# Release Note #85

**Topic:** Device Reading Disparities Pertaining to uM260-monitored Digital Panels.

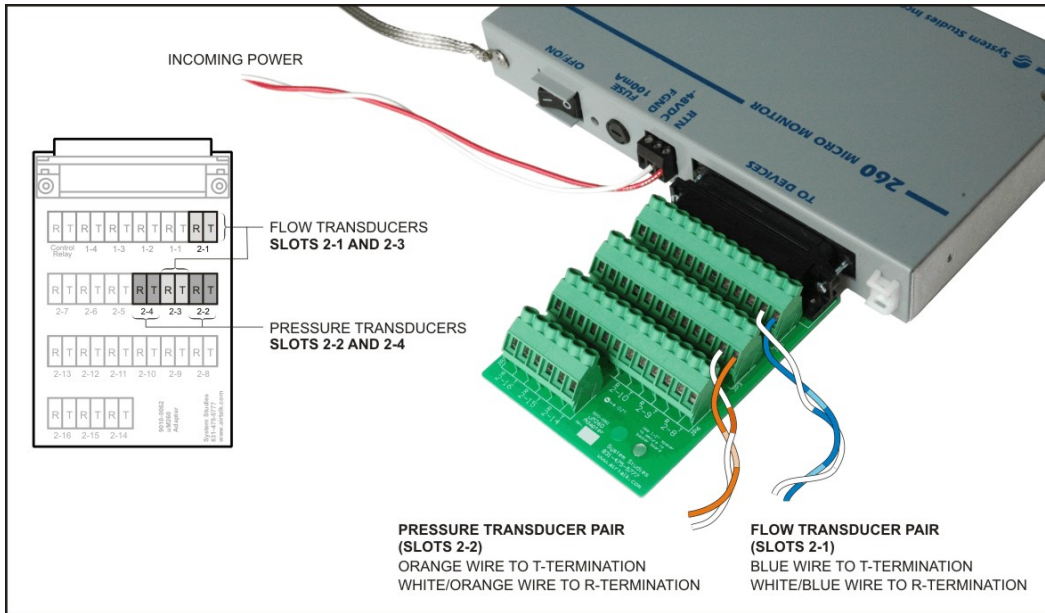
The original uM260 Micro Monitors manufactured by System Studies were equipped with blue surface-mount resistors located on the circuit board next to each relay. The purpose of these resistors was to simulate a busy signal when the device pairs were not being read by the monitor—to discourage unauthorized telco use of the pairs. The resistors were installed on uM260 monitors with firmware versions prior to version 1.16.

Unfortunately, uM260 monitors equipped with these resistors are not fully compliant with the System Studies Digital Panels. Reading discrepancies occur. For example, it is possible that a zero or near zero flow condition at the panel (as displayed on LED digital meter) could read 12 or 13 SCFH in PressureMAP or PressureWEB. This discrepancy is the result of the incompatibility of the uM260's on-board resistors with the digital panels—not the digital panel itself nor the PressureMAP software.

If you experience a reading error of this type, you should contact System Studies for instructions on how to check the firmware version of your uM260 monitor. If the firmware precedes version 1.16, arrangements will need to be made to return the monitor to System Studies so that the resistors can be removed. This procedure should not be attempted in the field.
